**Meridian Airport Authority - New Terminal**

**ADDENDUM NO. 1**

TO: All Bidders on the Above Referenced Product  
FROM: Davis Purdy Architects, PLLC  
DATE: June 13, 2024  
SUBJECT: **ADDENDUM NO. 1**

**A CURTAINWALL - EAST ELEVATION A**  
 3/8" = 1'-0"

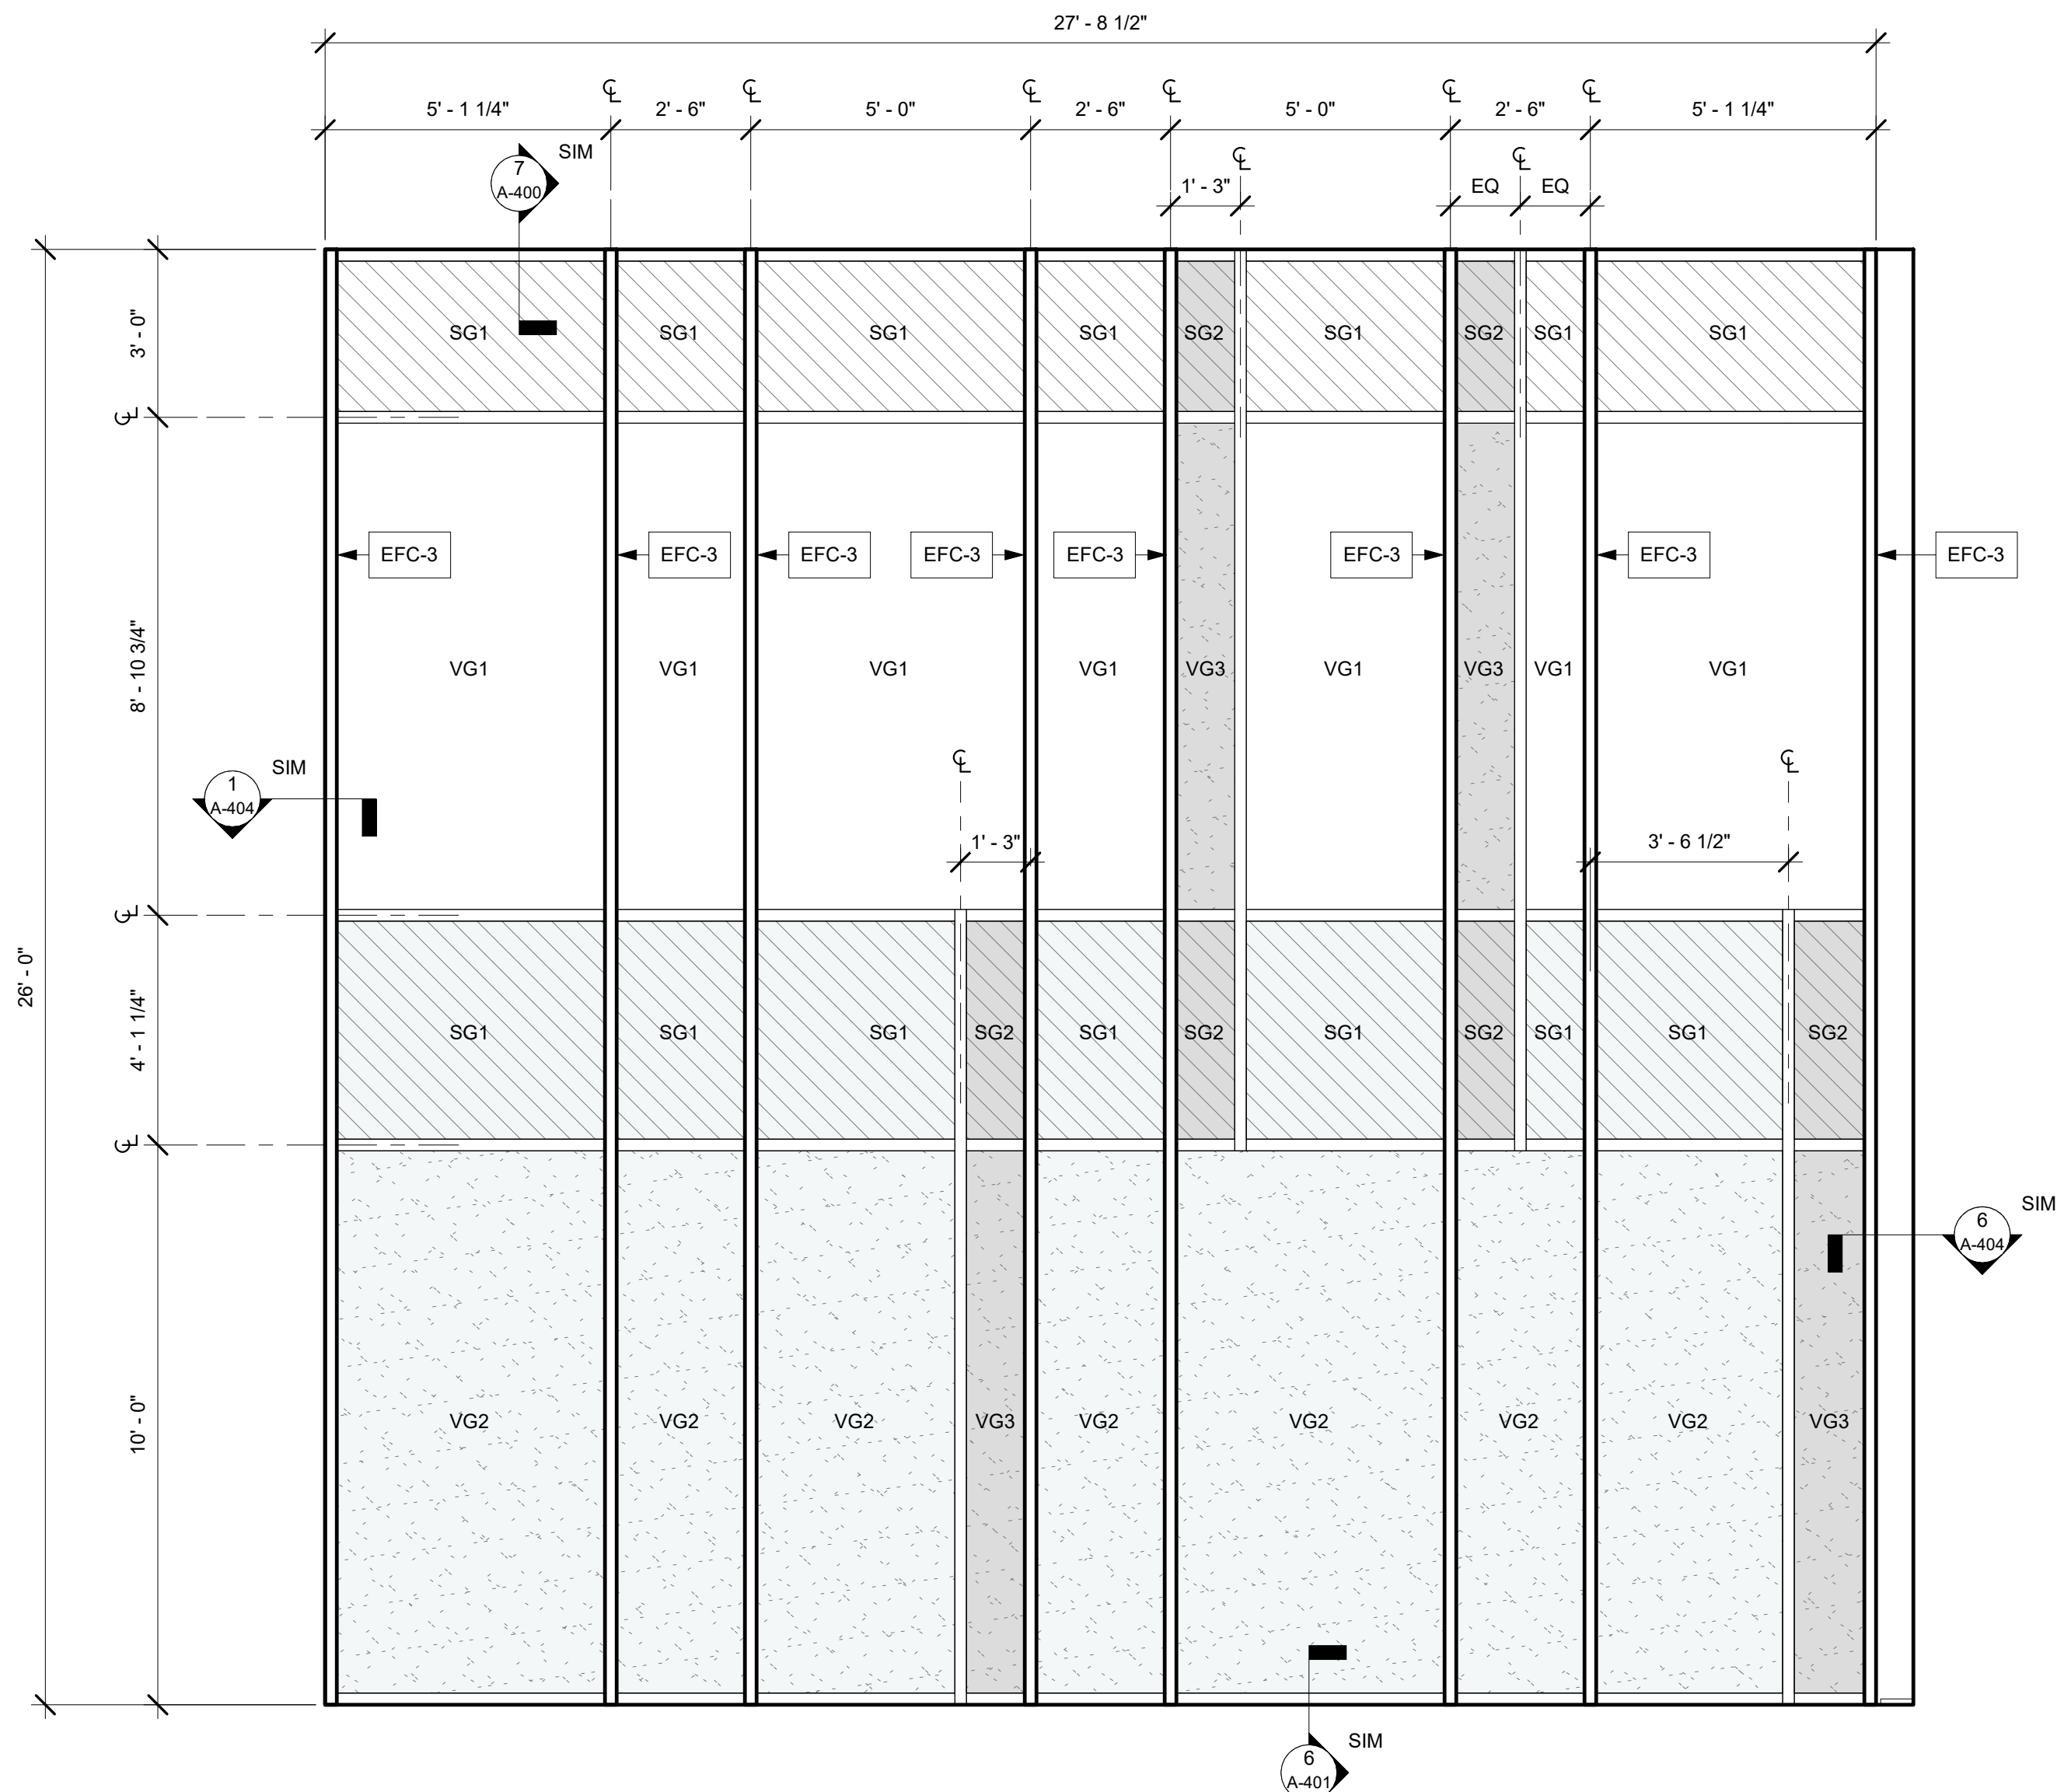
**14. CLARIFICATION/CHANGE:** Doors 2-101a & 2-101b (Curtainwall Elevation A) on drawings dated 5/17/24 are indicated as aluminum pair doors sized 6'-0" wide by 9'-10 3/4" tall. Change doors 2-101a & 2-101b to be aluminum single doors. Size is indicated on Architectural sheets A-900 & A-911 dated 6/13/24.

- 15. CLARIFICATION/ADD:** Add automatic sliding door to Curtainwall Elevation A. New door number is 2-101c. Size is indicated on Architectural sheets A-900 & A-911 dated 6/13/24.

- 16. DOOR 2-101c BASIS OF DESIGN:**
- a. ByPass Full Break Out (FBO) Door by Stanley Security Access Technologies, or equal.
- 17. CLARIFICATION/ADD:** Add automatic sliding door to Curtainwall Elevation A. New door number is 2-101c. Size is indicated on Architectural sheets A-900 & A-911 dated 6/13/24.
